CONSTRUCTION PLANS  
FOR  
**THE RIDGE AT LORSON RANCH FILING NO. 1**  
STREET & STORM SEWER CONSTRUCTION PLANS

THE RIDGE AT LORSON RANCH FIL NO. 1  
STREET / STORM SEWER  
CONSTRUCTION PLANS

DATE: NOV, 2021  
PROJECT NO: 100.066  
SHEET NUMBER: C0.1  
TOTAL SHEETS: 49

DATE:  
NOV, 2021  
PROJECT NO.  
100.066  
SHEET NUMBER  
C5.1  
TOTAL SHEETS: 49

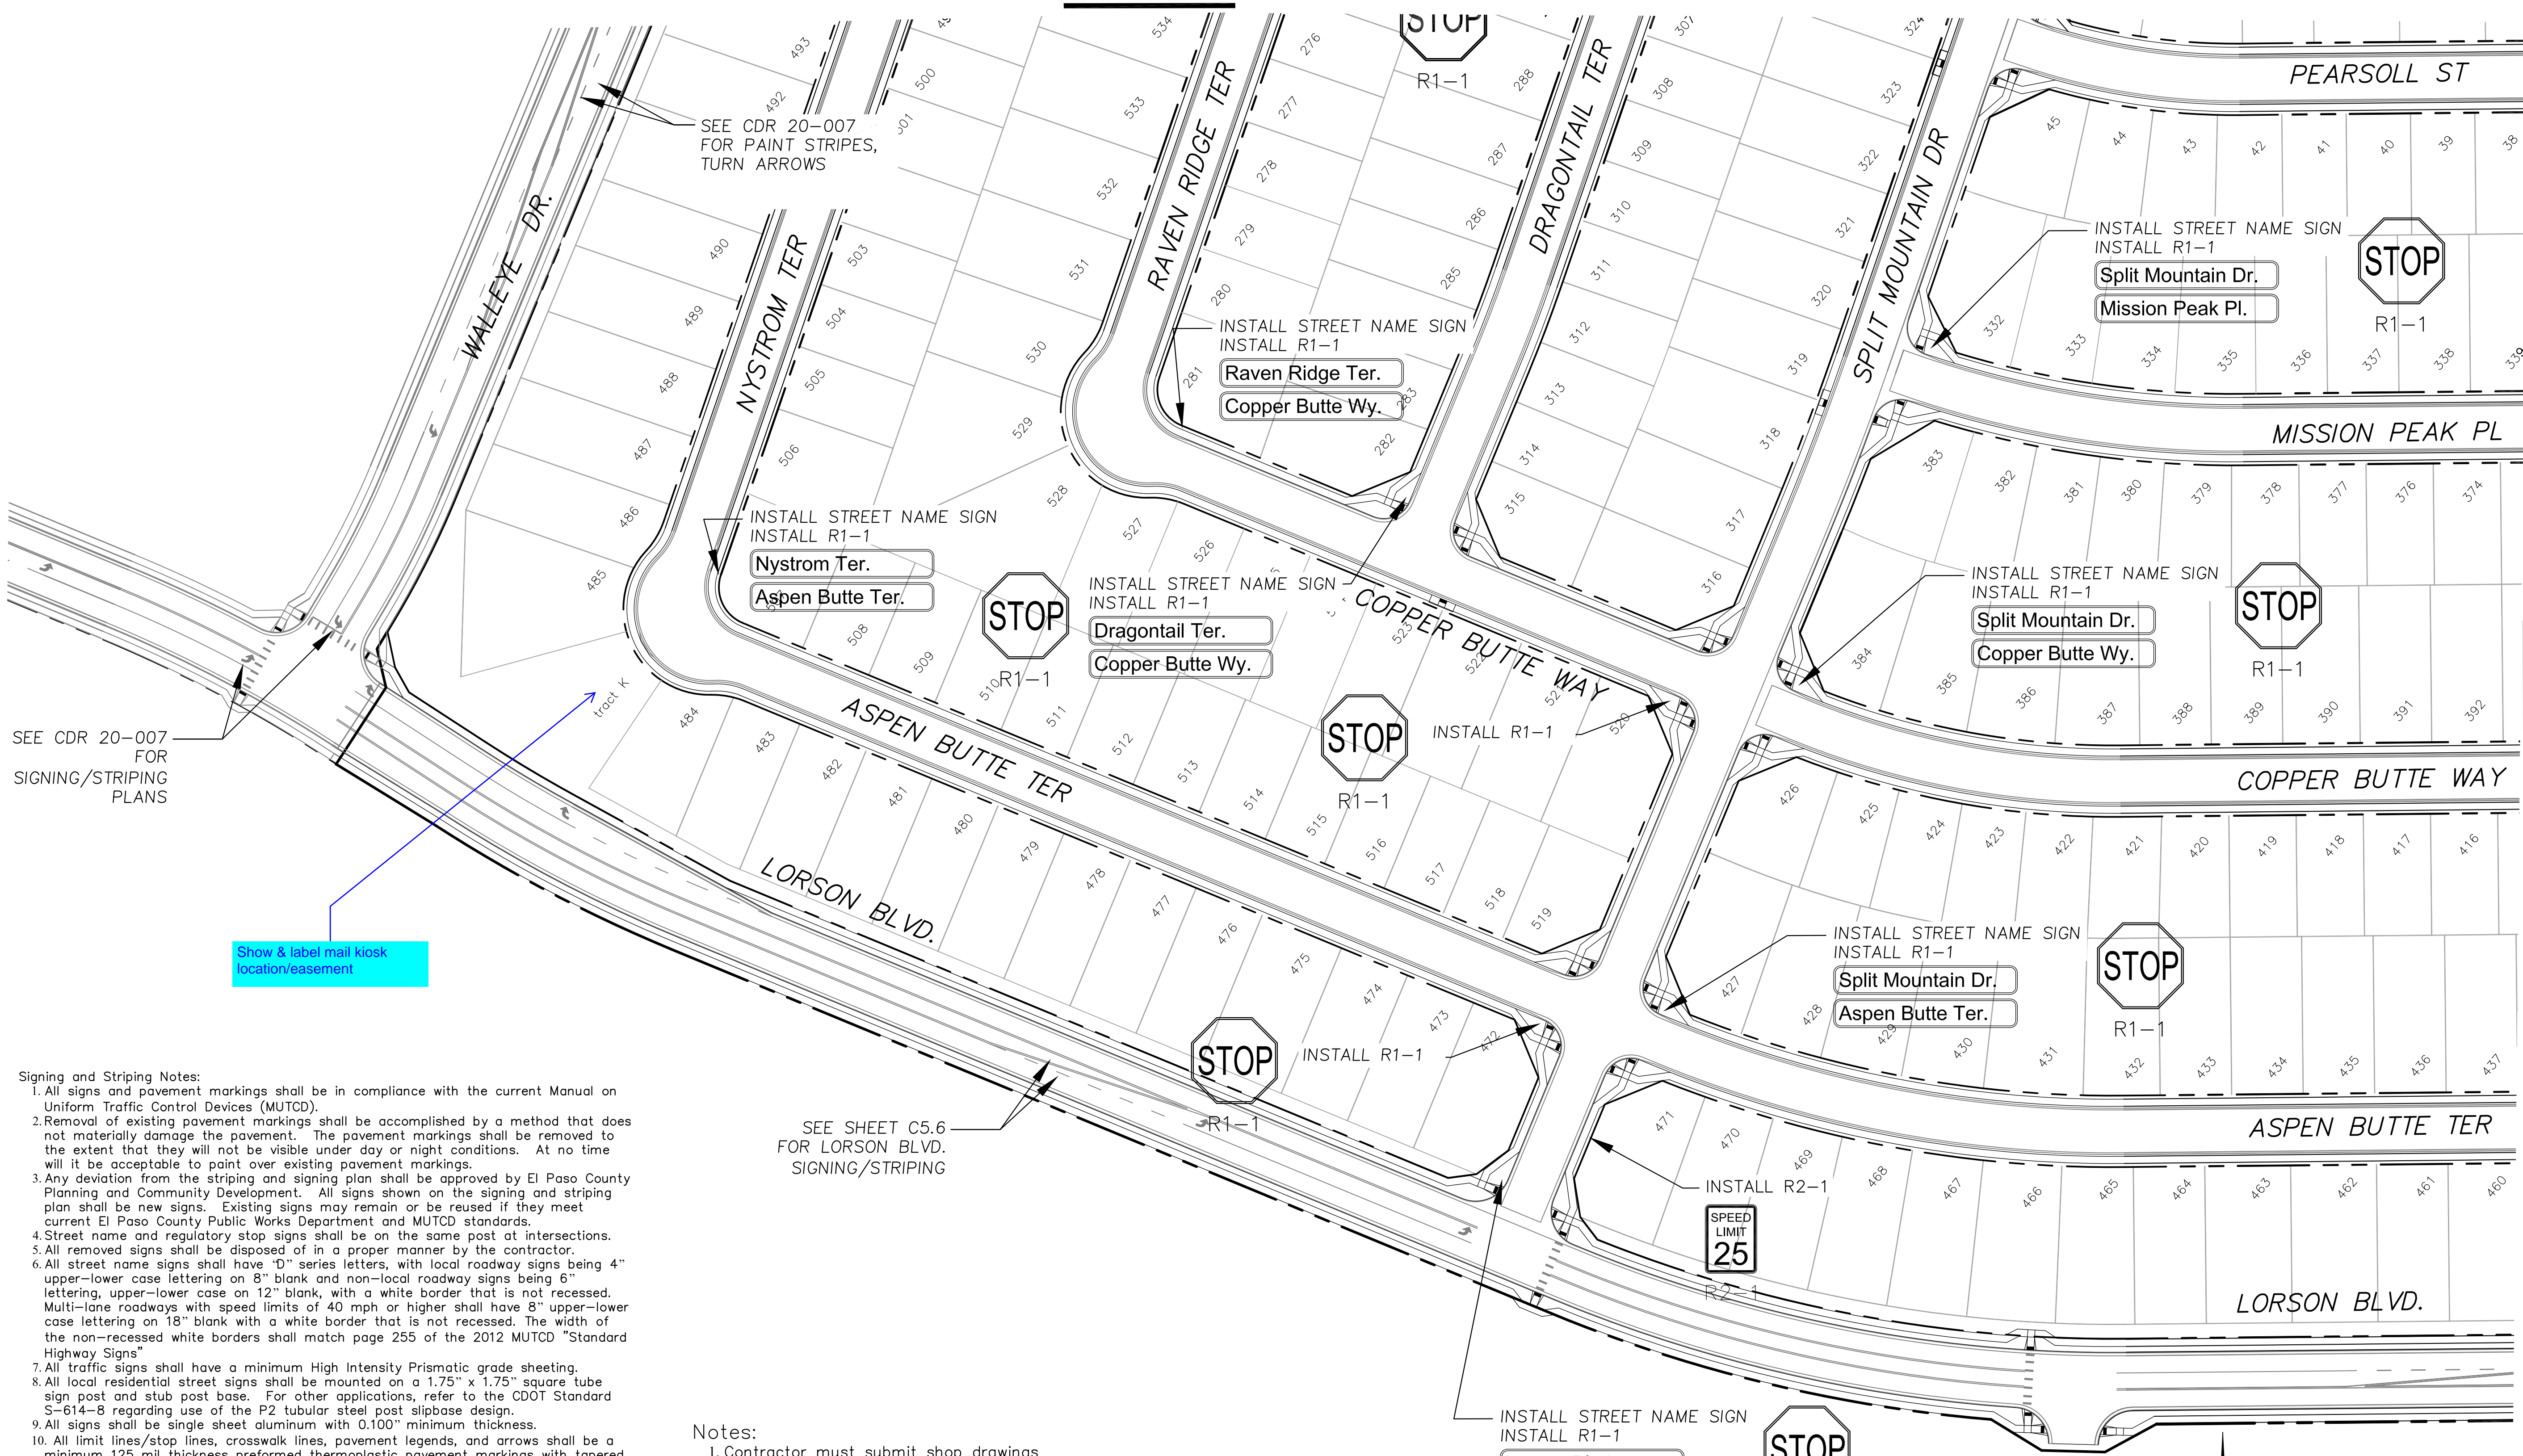
Show & label mail kiosk  
location/easement

LORSON BLVD  
 SIGNING & STRIPING PLAN

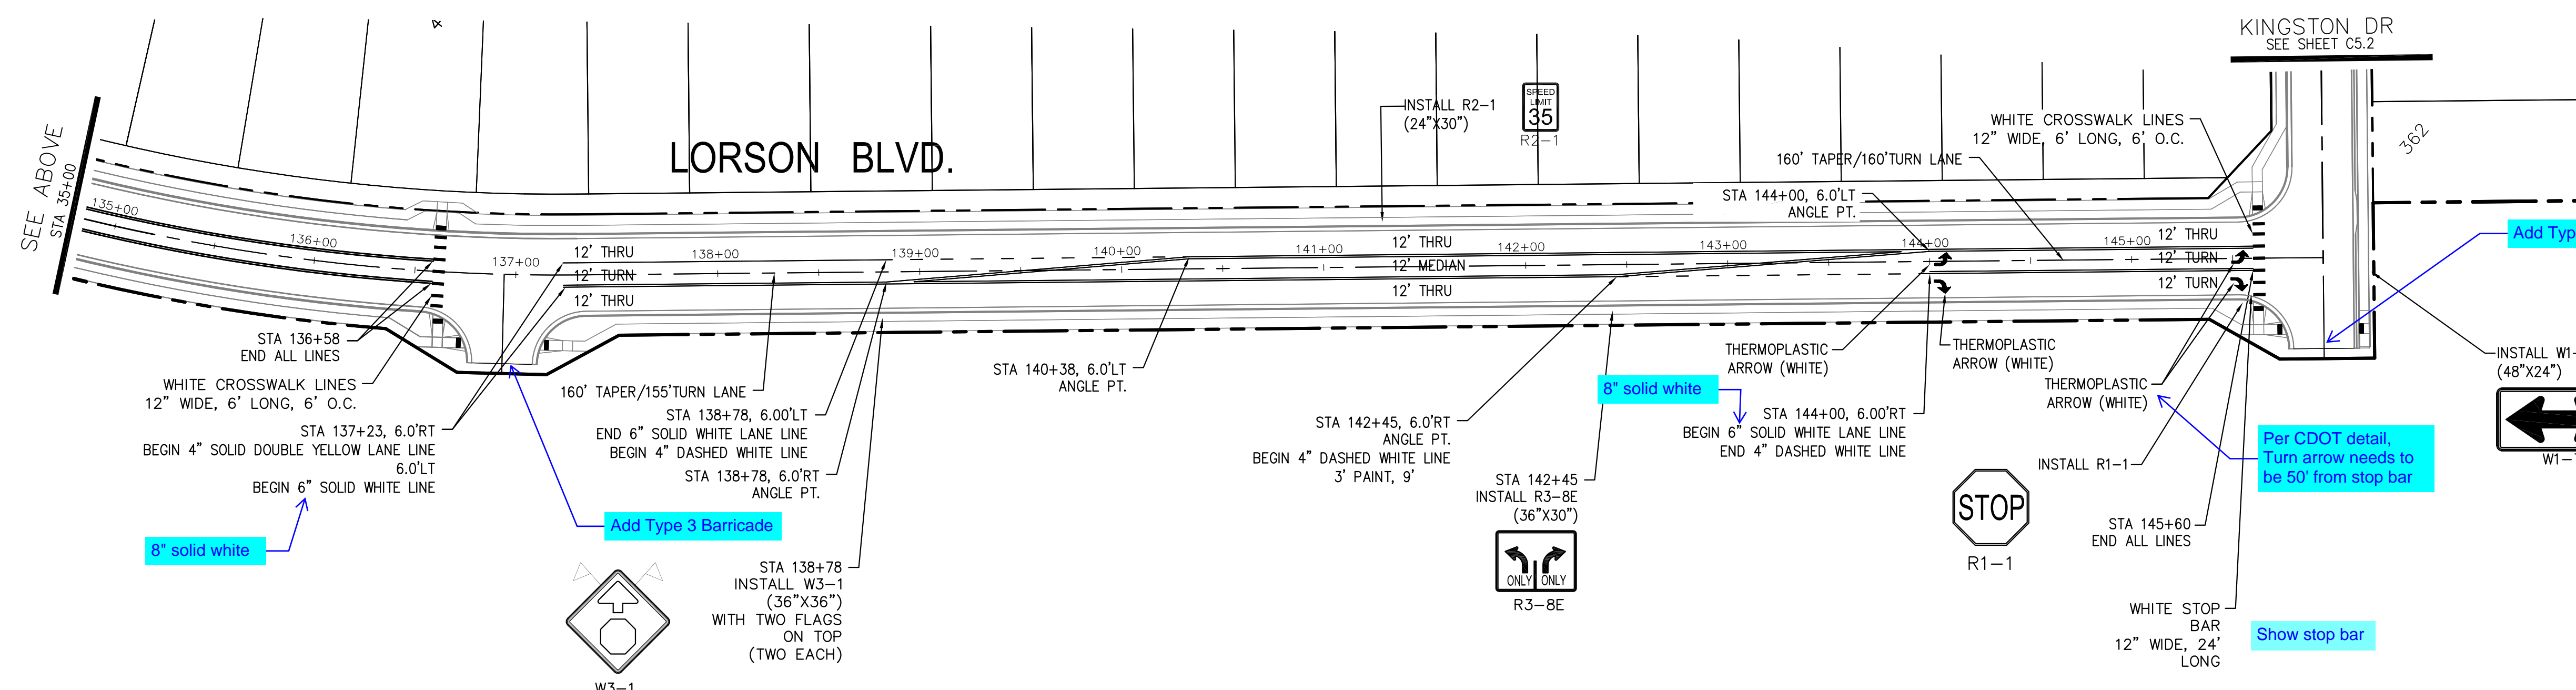
Provide details for pavement markings or reference CDOT standard striping detail sheet (S-627-1)

**FONTAINE BLVD. & WALLEYE DR  
 SIGNING & STRIPING PLAN**

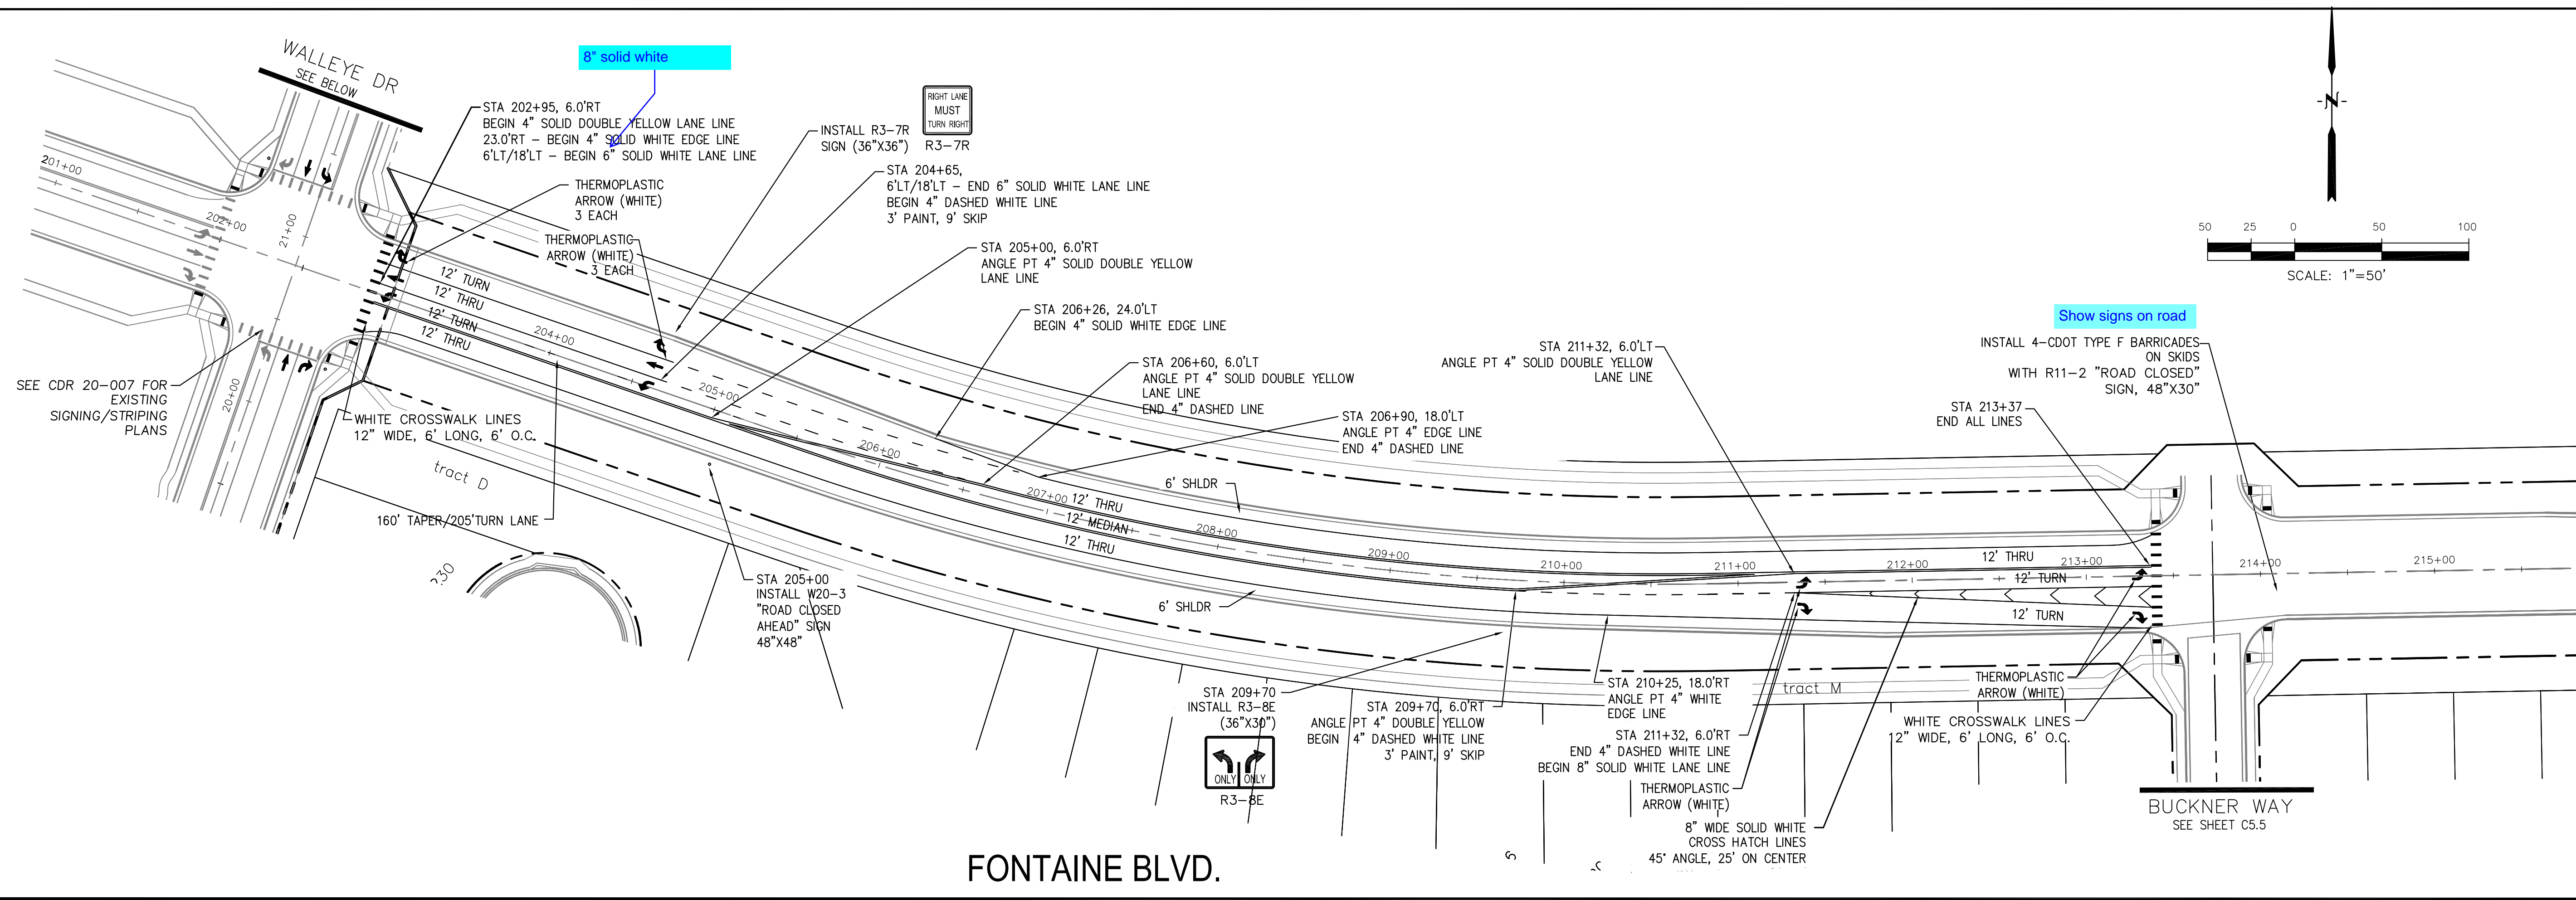
Add Type 3 Barricade

Per CDOT detail, Turn arrow needs to be 50' from stop bar

Show stop bar

SHEET NUMBER C6.2

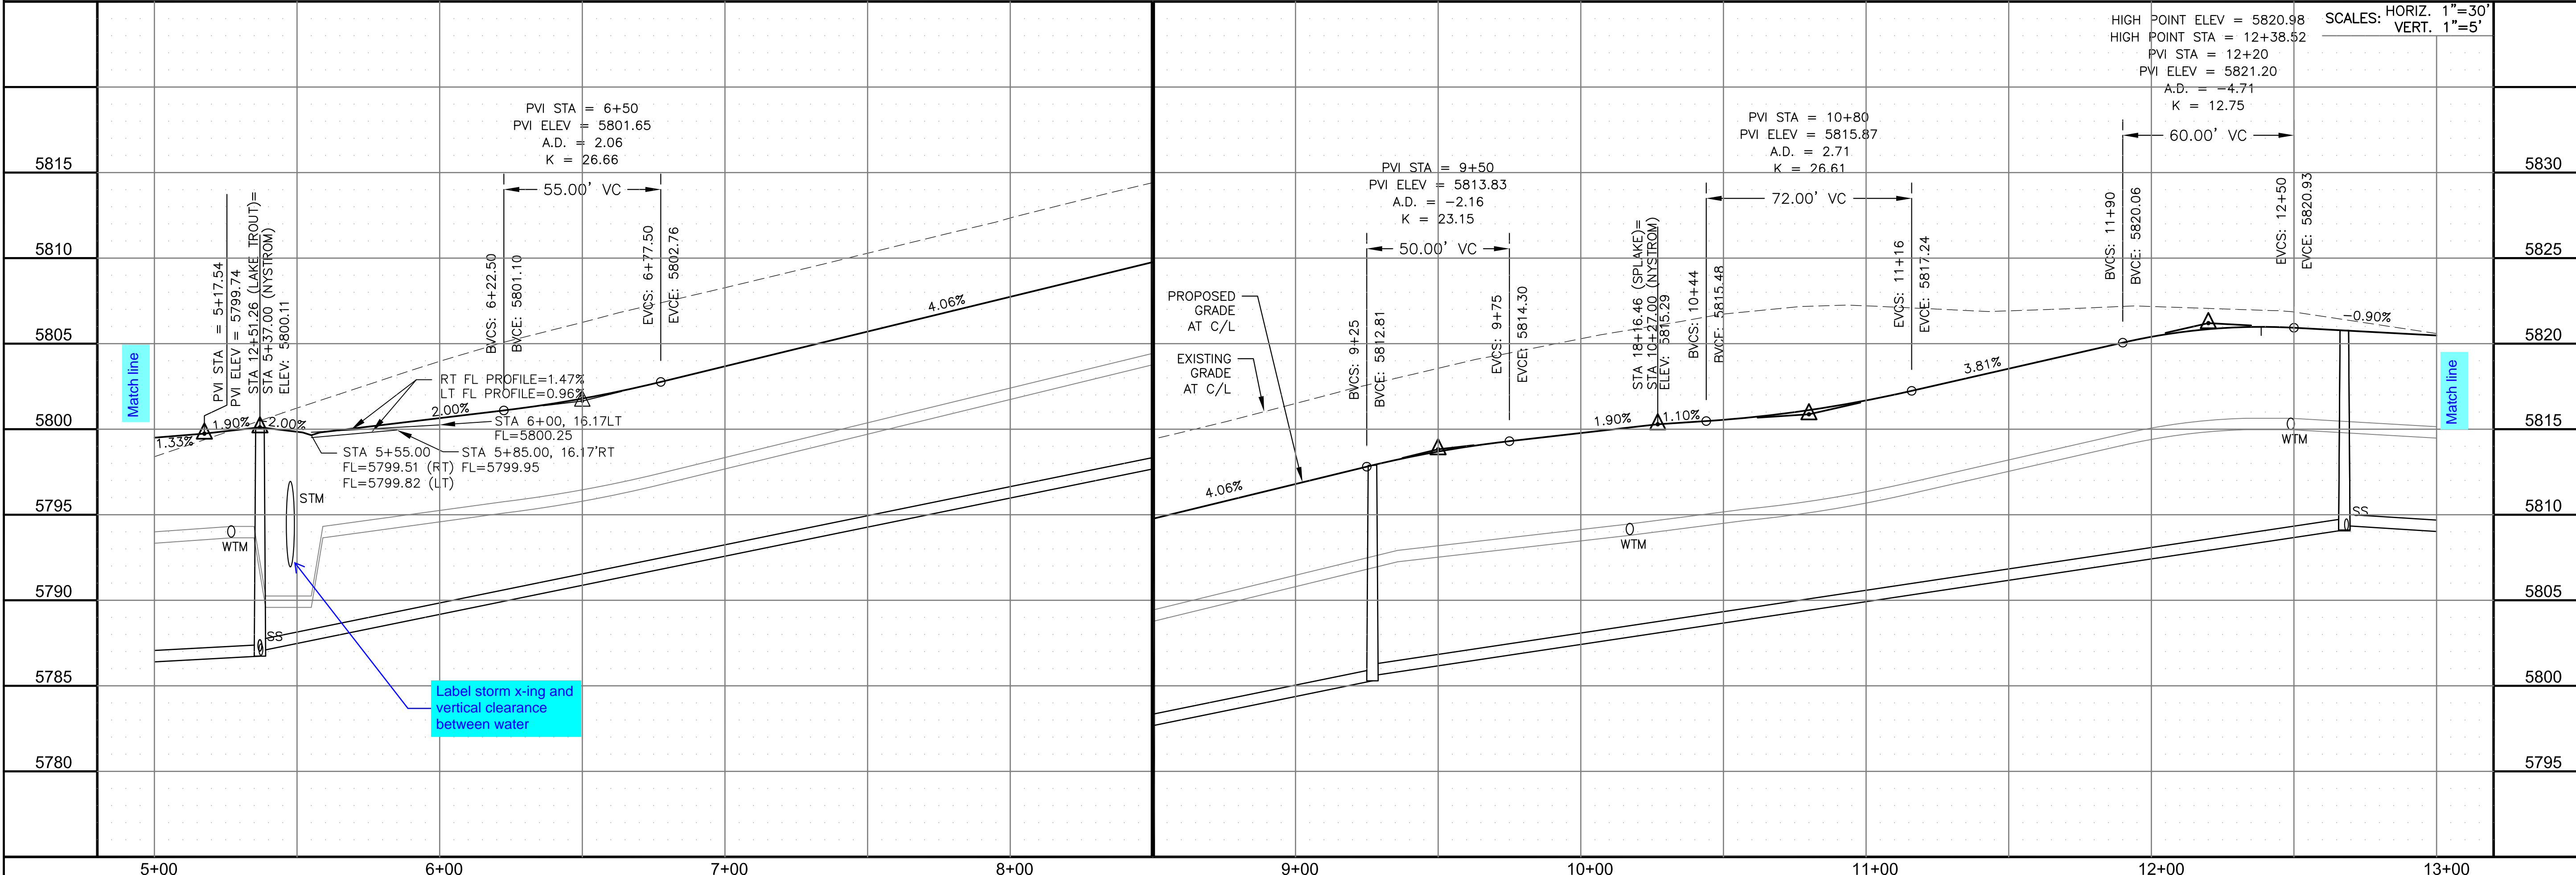
Label storm x-ing and vertical clearance between water
